**Officer Report for resource consents
RC-2024-0122 and RC-2021-0097-V10
Pursuant to Section 42A of the Resource Management Act)**

Consent Discharge permit; Change to conditions of combined discharge permit and land use consent

- **To discharge water contaminants (mixed landfill leachate and stormwater) from a retention pond to land; and**
- **To change condition 11 of RC-2021-0097-V10:**
 - **to enable any authorised discharge consents granted by the WCRC to contaminate groundwater or surface water outside of the site as a result of the exercise of consent RC-2021-0097, and**
 - **to update the application site's legal description.**

Activity type	Discharge
Activity subtype	Discharge of industrial and trade waste
Activity status	Section 88 application (RC-2024-0122): Discretionary Section 127 application (RC-2021-0097-V10): Discretionary
Applicant	Taylorville Resource Park Ltd
Site location	Taylorville Road
Grid reference(s)	42°26'40"S 171°15'46"E
Activity type	
Activity subtype	
Activity status	Discretionary
Recommendation	Decline

Figure 6: Durov Plot of GRE001 Water and Upgradient Locations

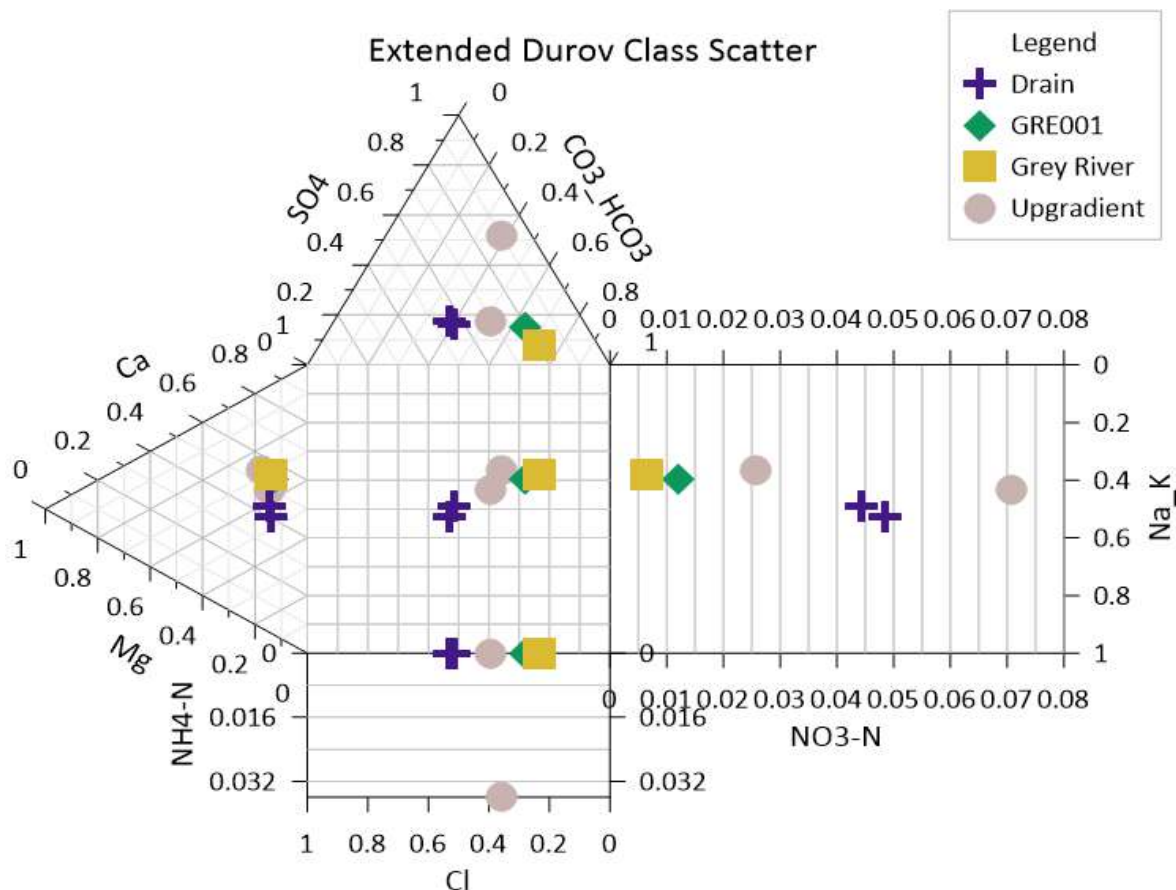
PDP notes that samples collected from TRD2 and TRD4 were not included in the comparison. We have revised our plot (Figure 6) to include only upgradient bores (MB1, MB19s), the Grey River (GR-01), untreated water for the GRE001 supply (PWT01), and the requested drain locations (TRD2 and TRD4). The drain locations were excluded from the original assessment due to the influence of other inputs along Taylorville Road and because water quality in samples collected from monitoring bores MB4, MB14, and MB18 are more relevant to assess inputs from the operations.

Figure A5.2 Extended Durov Class Scatter

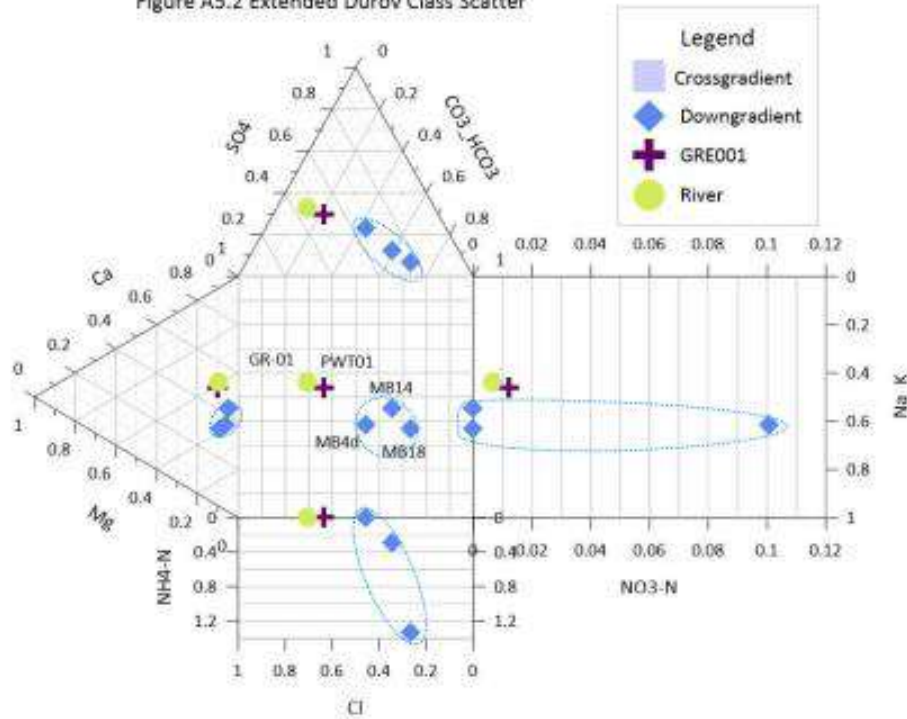
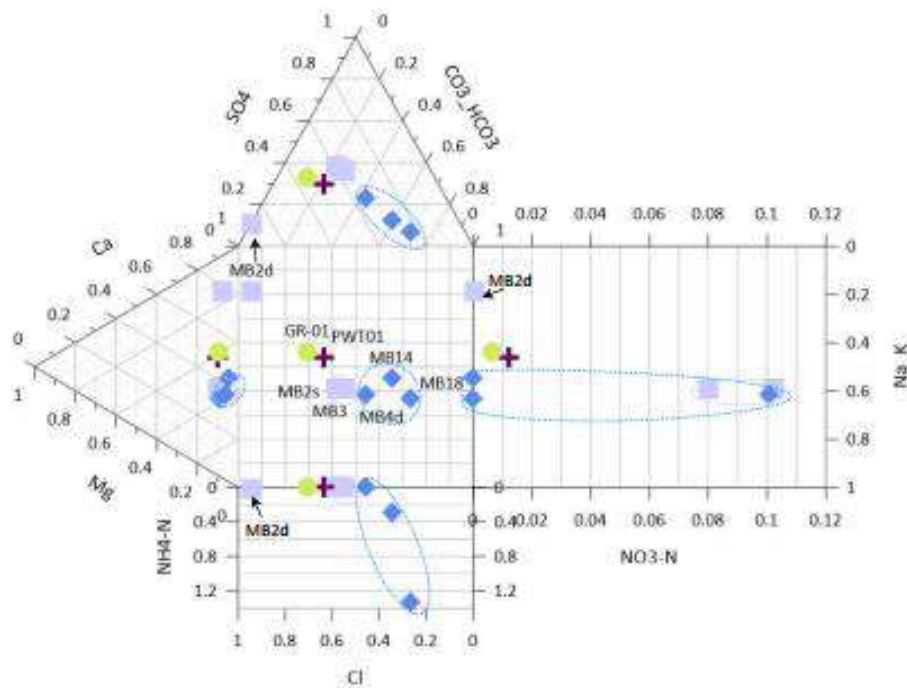
The results for ions were compared to October 2024 results from samples collected from monitoring bores MB2s, MB2d, MB3, MB4d, MB14 and MB18 and plotted on an extended Durov diagram (Figures A5.2 and A5.3 of the RFI response). These figures are shown below. ENGEO notes that bores MB2s, MB2d and MB3 are cross gradient bores, while MB4d, MB14 and MB18 are downgradient bores with respect to the waste storage areas.

- 12.3.** They provided interpretation of their updated plot in the memo, however I discuss problems with the plots in Paragraph 14 below.
 - 12.4.** ENGEO note there is another deposit of Pleistocene outwash on the south side of Taylorville Road, as indicated in their Preliminary Hydrogeological Assessment. I assume this is based on their inferred depositional sequence as shown in Figure 3, Photo 3 of that report, as per the red Gravel 1 extents on the southern side of the road shown on that figure. They state those gravels are not hydraulically connected to the subject site but consider ambient groundwater quality is likely similar in both deposits (north and south of the road). ENGEO note the GDC abstraction area is approximately 100 m due south of the Pleistocene deposits on the southern side of the road and infer that groundwater discharges from these deposits may be influencing water quality in the abstraction gallery rather than waters from upgradient of the site.

Figure 1. Bioresearchers Figure 1 showing an erroneous interpretation of the stream networks and locations of sampling sites that were not subsequently reported.

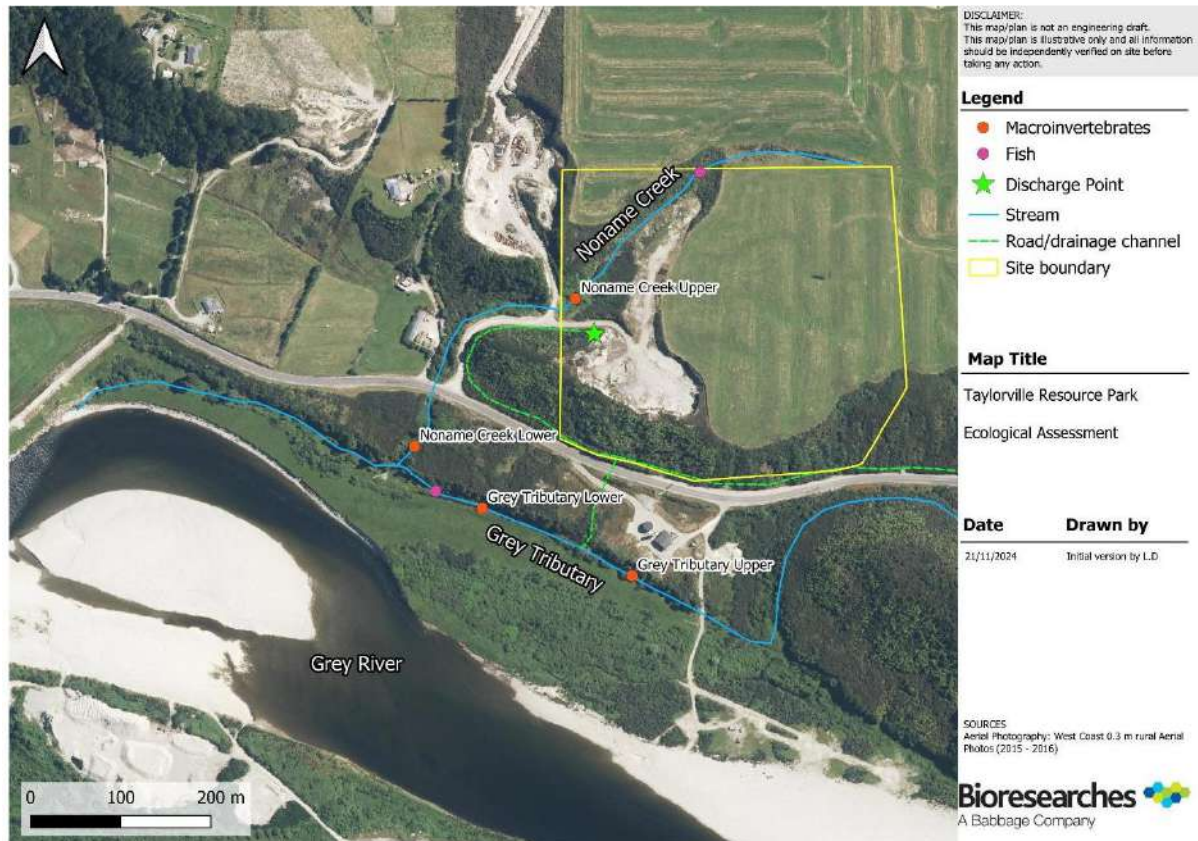
19. The Bioresearches EclA is a brief document informed by a site walk-over and images provided by an unknown party. It is not apparent that Bioresearches visited the site or what technical assessments were undertaken. Figure 1 of the EclA report (provided below as Figure 1) indicates that macroinvertebrates and fish were surveyed, but that information is not presented in the document. Throughout the report, there are statements made about values that have little to no basis or supporting material and are counter to my own interpretations of the limited information provided.

20. I note that the alignments of streams shown by Bioresearches (Figure 1) is incorrect and I have included what appears to be a correct interpretation of waterways presented in an ENGEO report from 17 March 2025 (see **Error! Reference source not found.** below). Further references to waterways in this evidence are as shown in Figure 2.

25. We note that Bioresearches Figure 1 indicates that the Noname Creek 2 and the Grey River Tributary are connected, and that the lower section of the Noname Creek 2 on the Grey River floodplain are not shown. In addition, the Bioresearches figure does not show the culverts beneath Taylorville Road that provide a pathway for drain water on the northern side of Taylorville Road to enter into the Noname Creek 2

Figure 2. Correct layout of surface water bodies at and adjacent to the Taylorville site presented in an ENGEO report from 17 March 2025. Note the location of the proposed discharge point of leachate to ground.

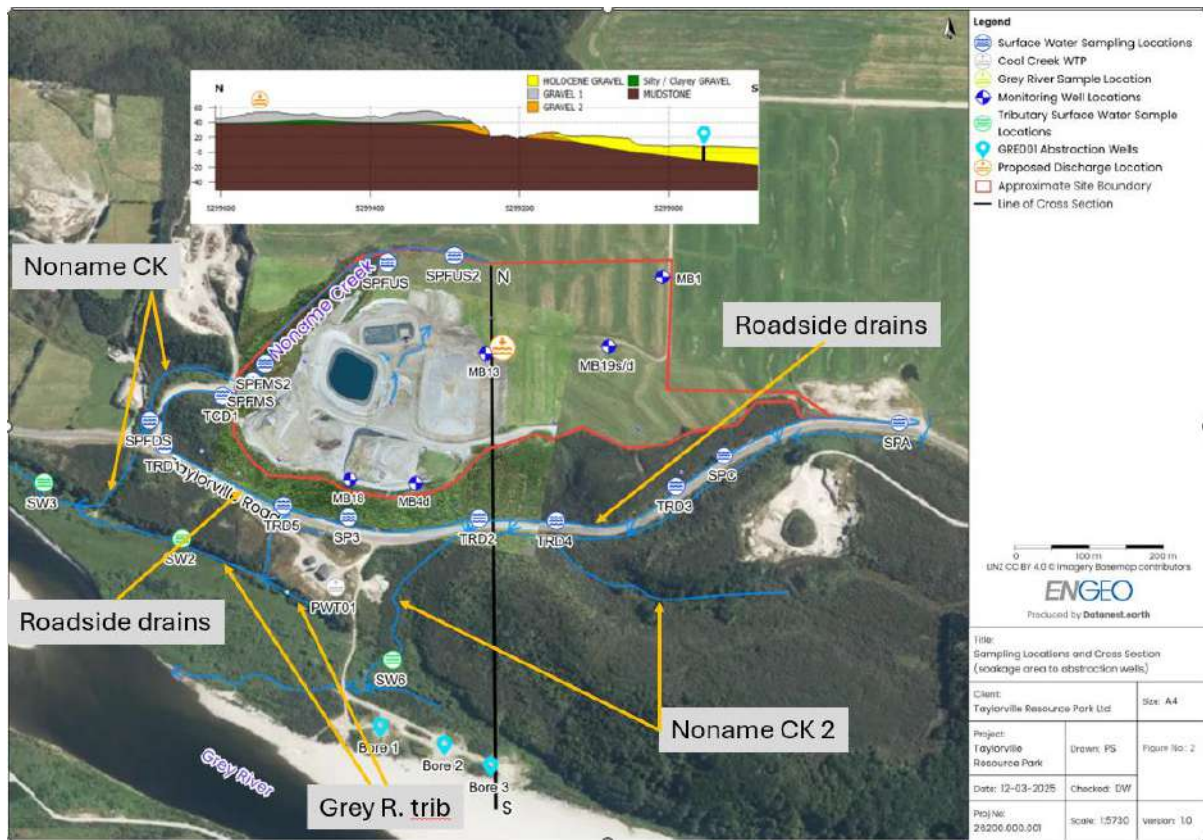
23. Further east along the road, the flow in the roadside drain changes direction on two occasions. Drain water flowing in opposite directions converges at culverts shown at the locations on Figure 2. The culvert at TRD5 drains water under the road into the Grey River Tributary as described above, while other culverts transfer water to another stream situated on the lower terrace surface below the road and which drains land to the east and south of the Grey District Council (GDC) Coal Creek water treatment plant. For the purpose of this review, the stream to the east of the GDC treatment plant is referred to as the Noname Creek 2 (Figure 2).

26. Our understanding is that in fact Noname Creek 2 ultimately flows across the flats on the floodplain of the Grey River in the vicinity of the GDC Coal Creek water supply bores before discharging to the Grey River. I note the ecological value of the Noname Creek 2 has not been assessed despite being in relatively close proximity to potential groundwater and surface water flow paths that could be affected by the proposed discharge to land.

43. My understanding, based on discussion with Carl Steffens, is that contaminated water proposed to be discharged to land at the location shown in Figure 2 will likely cause significant mounding of groundwater beneath the point of discharge, potentially causing a local increase in groundwater level by up to 8 m (groundwater may reach near the ground surface at the discharge point). This will affect local groundwater flow directions with potential
